# A428 Black Cat to Caxton Gibbet improvements

9.21 Applicant's Comments on Written Representations

**9.21 Applicant's Comments on Written Representations**

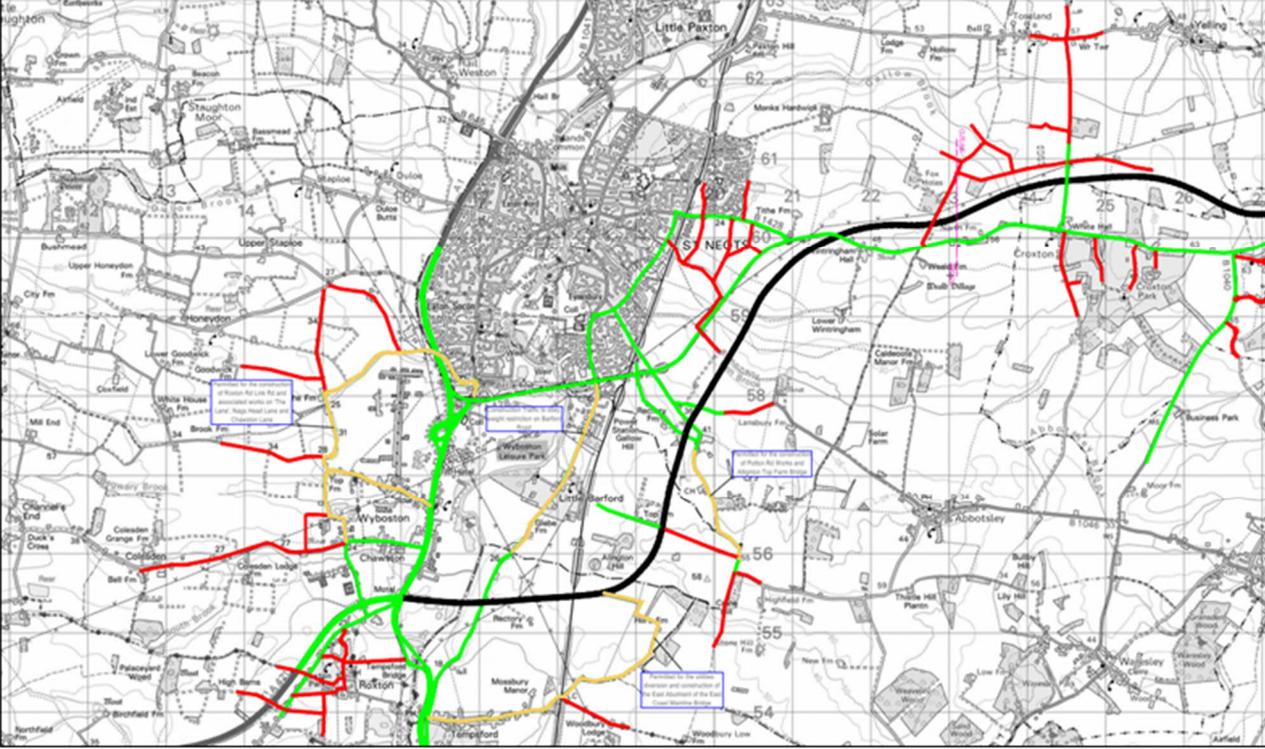
REP1-048p	<p>(c) Wyboston junction (Arcady)</p> <p>(i) Some observed u-turning traffic has been removed from the model and an explanation as to why that has been done is required.</p> <p>(ii) The morning peak hour model has been built for the hour 07:00-08:00 but examination of the count suggests the busiest hour is 08:00-09:00. An explanation of peak hour selection is required.</p> <p>(iii) Forecast year flows appear to be a combination of counted turns for the Premier Inn access and flows taken directly from the strategic model. Direct use of strategic model flows is not accepted.</p> <p>(iv) Some of the geometric measurements used in building the model are over-estimated, for example approach road widths, while some flare lengths have been underestimated. Documentation suggests the model was built using OS kerb data. CCC would further suggest aerial photo information is used as there is significant hatching at this junction and clearly marked road edging.</p>

Reference Number	Written Representation/Applicant Comment
	<p>(v) An independent model run for 2040 AM peak, using revised geometries and future year flows (derived using industry standard methods) shows a marked deterioration in junction performance compared with the Applicant modelling. This junction needs to be reassessed.</p> <p>(vi) Future year performance of this junction suggested by the Applicant is therefore not accepted.</p>
Applicant Comment	<p>The cumulative effect of Points (1) (ii) and (iii) above is that CCC assert that the 2015 base flows used in the Arcady model of this junction are 20% low relative to 2016 observed data for the reasons given above. In respect of the specific point about peak hours, for consistency with the strategic model, the local model junction for the Wyboston junction was run for the peak hours identified when the strategic model was built (0700-0800 and 1700-1800), which are not necessarily the same as the peak hours for this individual junction. Transport Assessment Annex [APP-243] para 2.2.6 refers to this.</p> <p>Point (iv) CCC have also raised a query over the way the geometry of this junction has been represented in the ARCADY model [REP1-048 2.5.5 (iv)]. The Applicant's consultant has re-visited this and considers the geometric measurements to be correct..</p> <p>Point (v) CCC consider that the models provided by the Applicant do not accurately represent future levels of performance at this junction.</p> <p>It is evident from the strategic model outputs and from the ARCADY model results tabulated in Tables 3-45 to 3-48 of the Transport Assessment Annex [APP-243], that the Scheme results in a substantial decrease in traffic flows along the existing A428 through the junction and that this results in a substantial improvement in the capacity of the junction overall. This improvement will take place whichever set of base flows are used.</p> <p>The Applicant acknowledges that, with the modelling undertaken, by 2040, this junction will have reached its design capacity once again (max RFC=0.85) and a higher level of base flows would probably result in this capacity threshold being exceeded. But still the impact of the Scheme will continue to be better in comparison to the "without scheme" scenario.</p> <p>While we acknowledge that the modelling shows an increase in flows along Great North Road (north), the LIR (para 7.2.6) acknowledges that this is an effect of traffic re-routing within St Neots to access the wider road network via the Wyboston junction and is linked with a predicted significant reduction in traffic using the B1428 Town Bridge and other roads in the town centre. In the LIR, the Councils have welcomed this reduction.</p> <p>On opening of the Scheme, the removal of through traffic from the existing A428 would benefit local traffic which would seek optimal routes through the local area. The Applicant's position is that it would not be reasonable or proportionate to</p>

Applicant Comment	<p>The Applicant considers that the reference to the "traffic conditions in London" by CCC is misleading here. The difference between the default standstill distance and the standstill distance adopted on some roads is 30cm (1.5m compared to 1.2m). The difference is relatively small and will only make a significant difference if a large number of vehicles were in the queue.</p> <p>The driving behaviour has a single parameter, standstill distance, which in some cases were set as 1.2m rather than 1.5m – the Applicant has now tested the impact of changing these parameters on multiple junctions.</p> <p>'Urban motorised' is a default driving behaviour in Vissim – it simply means vehicle don't exhibit overtaking behaviour on the outside lane, as on highways, but display the behaviour one would see at a junction, with free lane choice. This is not specific to London nor specifically for urban roads.</p> <p>The Applicant will be undertaking sensitivity tests changing the model parameters in line with CCC's suggestion, on a few selected junctions, and the impact on the new outputs of the model will be compared with the model outputs of DCO submission, and reported.</p>

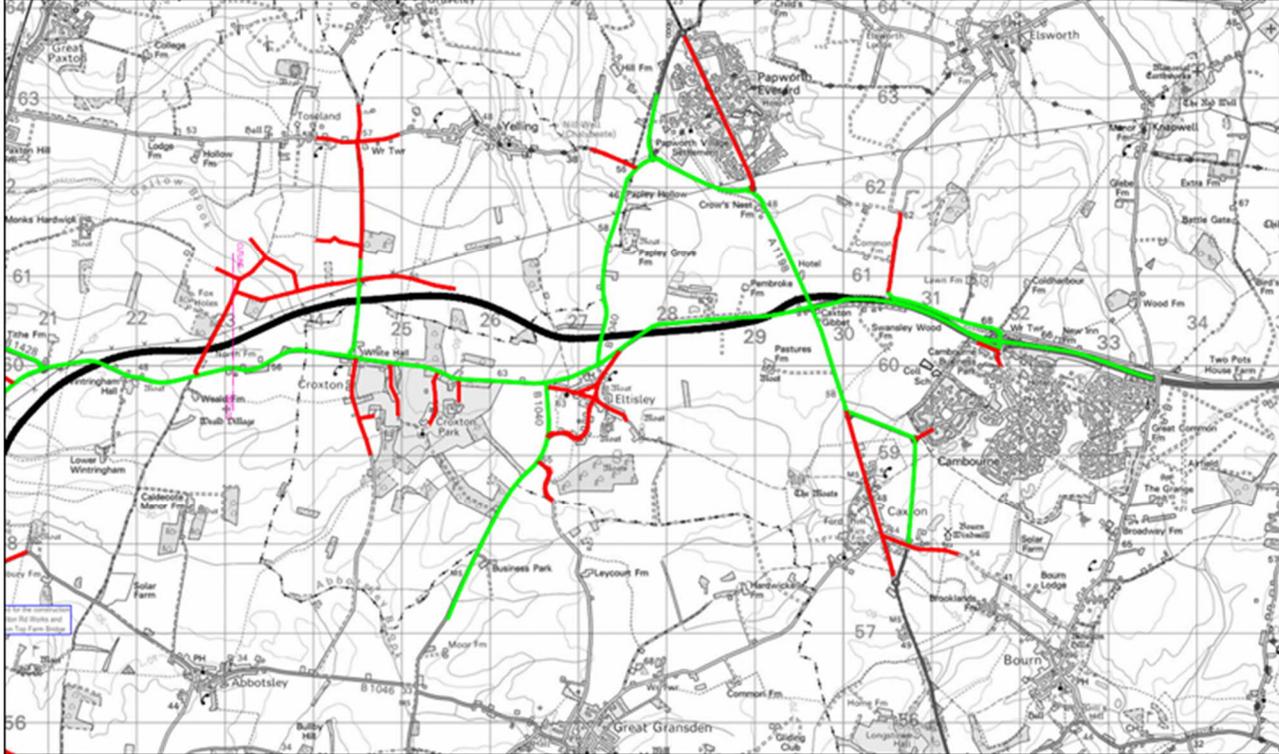
REP1-048r	2.5.8 Vehicles overlap in the models which overestimates the capacity at a junction.

Reference Number	Written Representation/Applicant Comment
Applicant Comment	<p>The Applicant seeks clarification about which junction is being referred to.</p> <p>However, based on information provided separately by CCC, it is assumed that this point is for the A1303/Cambridge Road junction which is one of several junctions in the M11 Junction 13 Vissim model network.</p> <p>It is noted that this junction operates with a mixture of courtesy/cooperative behaviour and aggressive merging behaviour, due to eastbound queuing on the A1303 through the junction and long queues on Cambridge Road resulting in aggressive merging onto the A1303. Replicating this behaviour in the Vissim model was complex and required calibration of the priority rules, with reference to video footage, to achieve a good match with observed delay from the A1303/Cambridge Road.</p> <p>The operation of this junction was reviewed in the model and it is acknowledged that there are a few vehicles overlapping, which are very few in numbers and this is a visualisation anomaly of the PTV Vissim software, not a real life representation of collision. The validation statistics of journey times on the eastbound approach to the junction on the A1303 and along the Cambridge Road are good, hence those visual and theoretical overlapping of the vehicles have been considered to be acceptable as they tend to happen in any Vissim model where the congestion and conflicts are significant.</p>

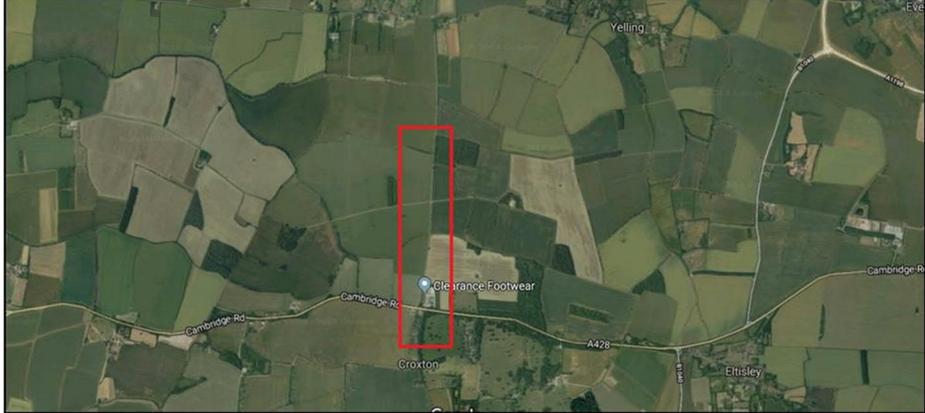
Reference Number	Written Representation/Applicant Comment
	<p>This approach is not untypical and for example it has been adopted on the existing A421 to the west of the Scheme. In addition, this approach has been directed by both Bedford Borough Council and Central Bedfordshire Council for the new rural side roads required by the Scheme and under their authority.</p>
REP1-048ai	<p>4.9 Departures from Standards: The views of other local authorities</p> <p>4.9.1 The Applicant's Technical Note dated December 2020 states that "<i>The basis of design has been discussed and agreed with Bedford Borough Council and Central Bedfordshire Council for the side roads they are responsible for. The basis of design was not fully discussed with Cambridgeshire County Council as they were unable to engage without a Planning Performance Agreement in place.</i>" CCC side roads "...have been designed on the same basis as Roxton Road and Barford Road to maintain the existing carriageway width and the basic cross section."</p> <p>4.9.2 Other Local Authorities may have taken the view that there are exceptional situations that necessitate DfS within their jurisdiction, CCC as LHA has not been party to such discussions. The basis of design was not discussed at all with CCC as LHA prior to August 2020. The Applicant's team took the decision to design the side roads in CCC's administrative area on the same basis. CCC's comments on the proposed design were provided in a timely manner, well in advance of the DCO application. The Applicant has not taken account of them.</p>

Applicant Comment	<p>4.9.1 and 4.9.2 – The Applicant notes the comments made by Cambridgeshire County Council regarding other local authorities.</p> <p>In May 2018, the Applicant sent an example side road technical note for the Council review – no comments pertaining to the reduced carriageway were provided. In July 2019, the Applicant sent an example Departure from Standards relating to the reduce carriageway. At no point before August 2020 did the Council inform the Applicant, that the Design Manual for Road and Bridges were their required standards, or that they would not accept a reduced carriageway, only that the Applicant was working at risk and that a governance process was required.</p> <p>The Applicant maintains its view that isolated sections of wider roads will increase driver speeds and increase the temptation for drivers to attempt overtaking which may lead to accidents.</p>
